Project: Pearl Street Center
92-100 Pearl Street, Essex Jct.
Date: January 25, 2018
From: Roger Dickinson, PE, PTOE
Subject: Access and Internal Traffic Circulation

RE: Pearl Street Center Proposed Site Plan Application
92 & 100 Pearl Street

We are writing on behalf of Jiddu / Sittu Trust to request a Site Plan approval involving the redevelopment of the above referenced two adjacent properties. We have reviewed the comments made by Jeffrey Kershner, P.E. from Hamlin Consulting Engineers, on February 13, 2018 and offer the following responses:

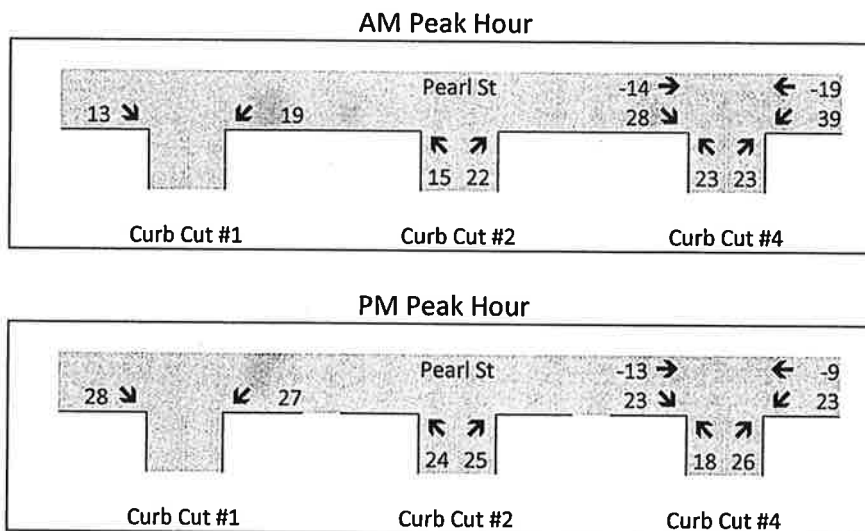
Redevelopment of the three parcels commenced in 2017 by converting the 9,670 sf auto dealership building into a Dollar Tree variety store. The two curb cuts serving that parcel were modified at that time so that the westernmost one (CC #1) is now a one-way entrance, and the next one to the east (CC #2) is now a one-way exit.
